SUNDRY NOTICES AND REPORTS ON WELLS

Sylvite Federal #2

Request permission to P&A Well.

Sylvite Federal No. 2

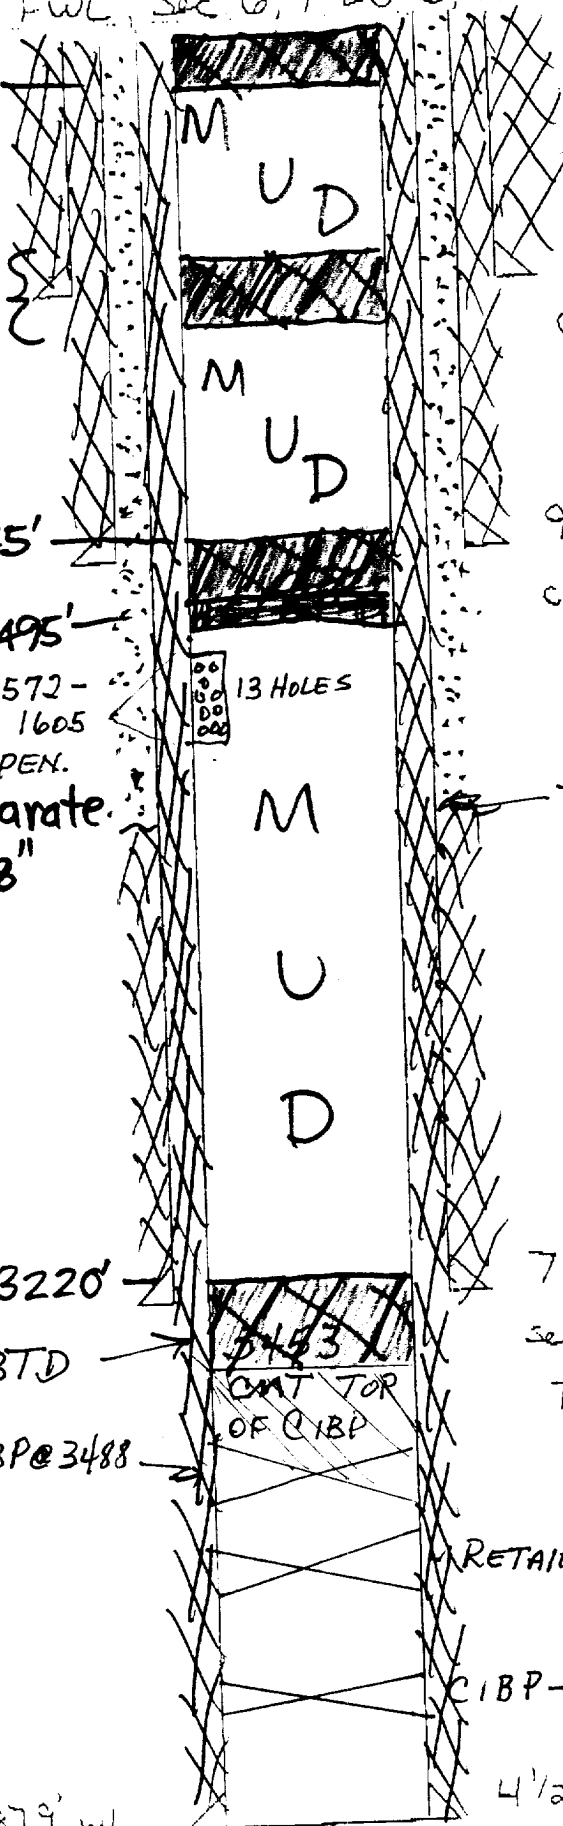
④ spot 50' surf. plug. 50'

③ spot 100' cmt plug
across 13 3/8" shoe. 9 5/8" x
Squeeze 300 ex in 100'
7" Annulus

② Set CIBP @ ~1500' 1275'
cap w/ 35' cmt and
then place enough cmt 1495'
atop that plug so that
TOC is tied back 50' 1572 -
into 9 5/8" csq. @ ~ 1605 OPEN.
1327' — OR spot separate.
100' plug across 9 5/8"
shoe.

① spot 100' cmt plug
across 7" shoe @ 3269', 3220'
OR place sufficient
cmt. atop existing PBT D
cmt. cap on CIBP
so that TOC is CIBP @ 3488
@ ~ 3220'
